DESIGN FEATURES

5.0 DESIGN FEATURES

MARKUP OF CURRENT ANO-2 TECHNICAL SPECIFICATIONS

FIGURE 5.1-3

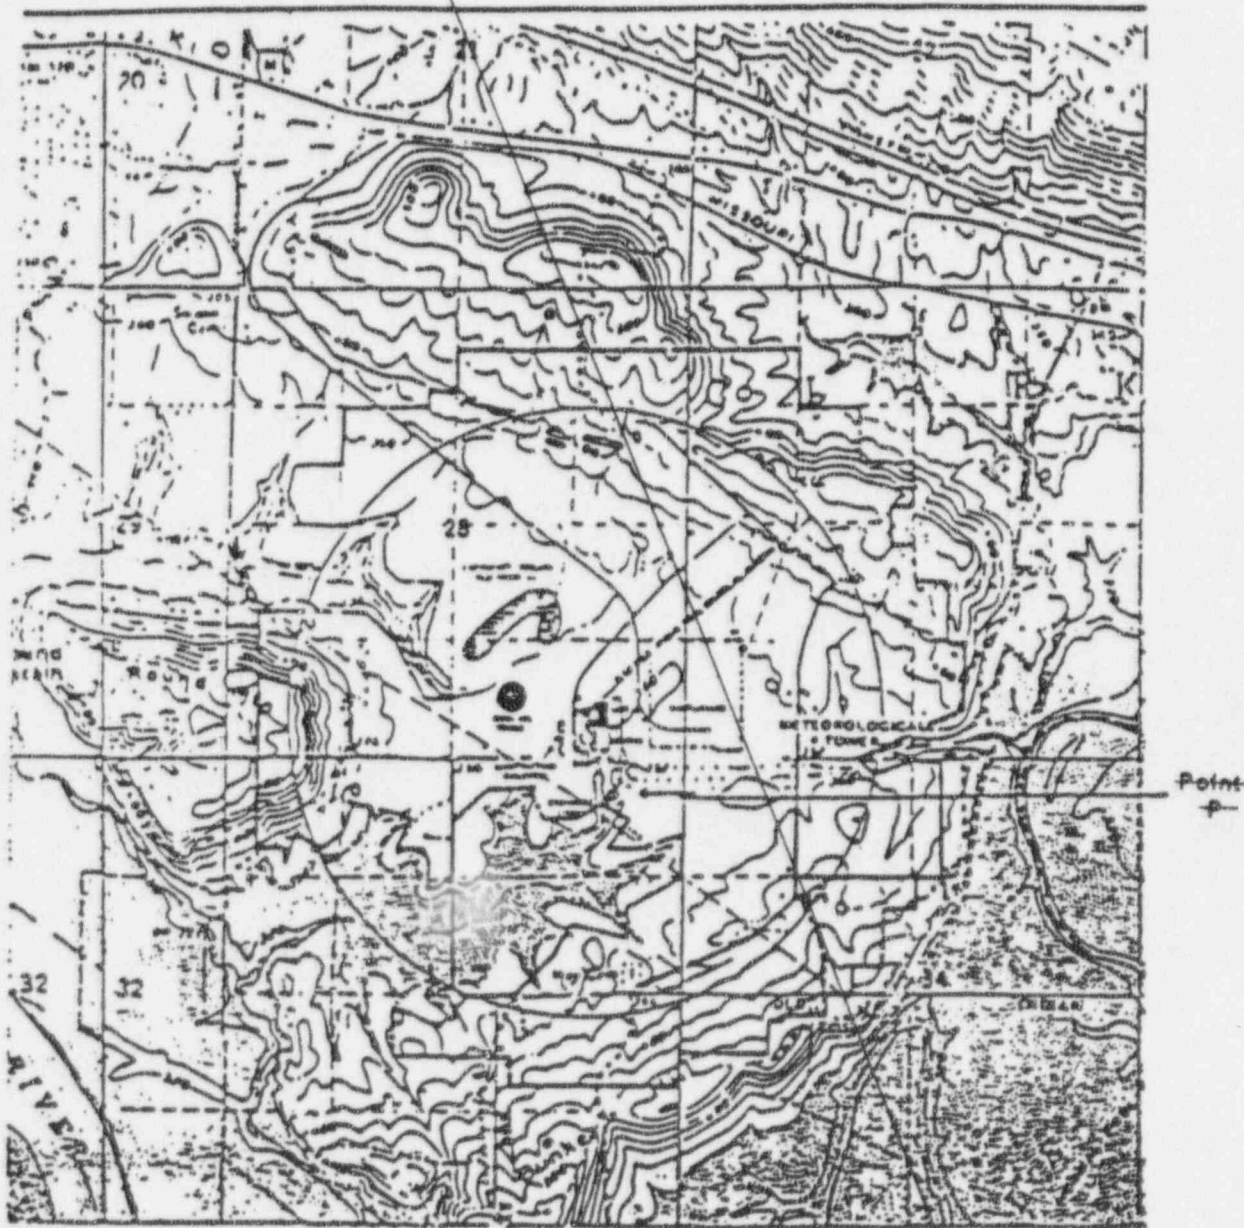
3.11.2.1 The dose rate due to radioactive materials released in gaseous effluents from the site to UNRESTRICTED AREAS (see ODCM Figure 4-25.1-3) shall be limited to the following:

3.11.2.2 The dose due to noble gases released in gaseous effluents from ANO-2 to UNRESTRICTED AREAS (see ODCM Figure ~~4-25.1-3~~) shall be:

DELETED

3.11.2.1 The dose rate due to radioactive materials released in gaseous effluents from the site to UNRESTRICTED AREAS (see ODCM Figure 4-2) shall be limited to the following:
